Model: Roll Feeder Type240 A/B for N-C1		Date: 3-Jun-04	No.: MB641001
Modified Article: Decal: Cutter: Caution: Multi (-27 only)		Prepared by: F.Noguchi	
From: 2nd Tech. Support Sec. Service Support Dept.			
Reason for Modification:	☐ Parts catalog correction ☐ To facilitate assembly ☐ Part standardization	☐ Vendor change ☐ To improve reliability ☒ Other	☐ To meet standards ()

Model: R/F Type240A/B for Neptune-C1	Date: 24-Dec-04	No.: MB641002a
--------------------------------------	-----------------	----------------

Model: R/F Type240A/B for Neptune-C1		Date: 17-Jan-05	No.: MB641003
Modified Article: Heater : 230V: 18W: 130C: CHN		Prepared by: F.Noguchi	
From: 2nd Tech. Support Sec. Service Support Dept.			
Reason for Modification:	☒ Parts catalog correction ☐ To facilitate assembly ☐ Part standardization	☐ Vendor change ☐ To improve reliability ☐ Other	☐ To meet standards ()

New part number	Description	Q'ty	Page	Index	Note
B8512980	Spacer: Paper Holder: CHN	2	2	17

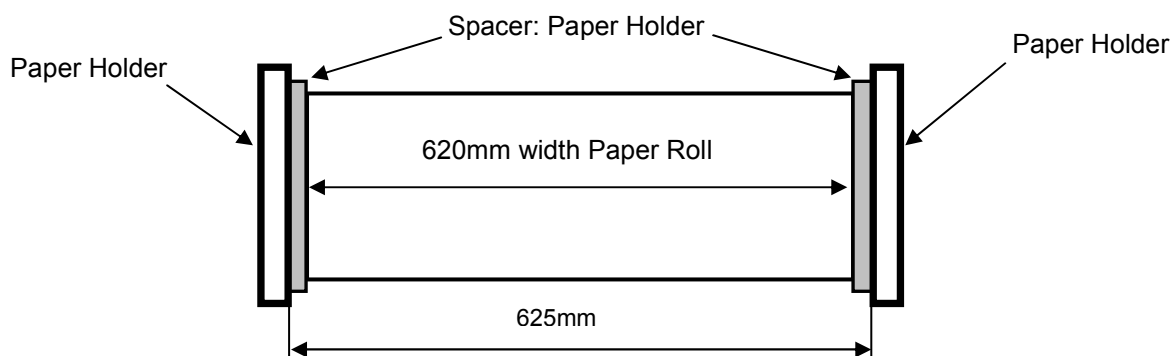
Change: A spacer was added to the roll holder (green, ring-shaped, 2.5mm width).

Reason: To make it possible to attach a 620mm paper roll (using the holes marked for "625mm").
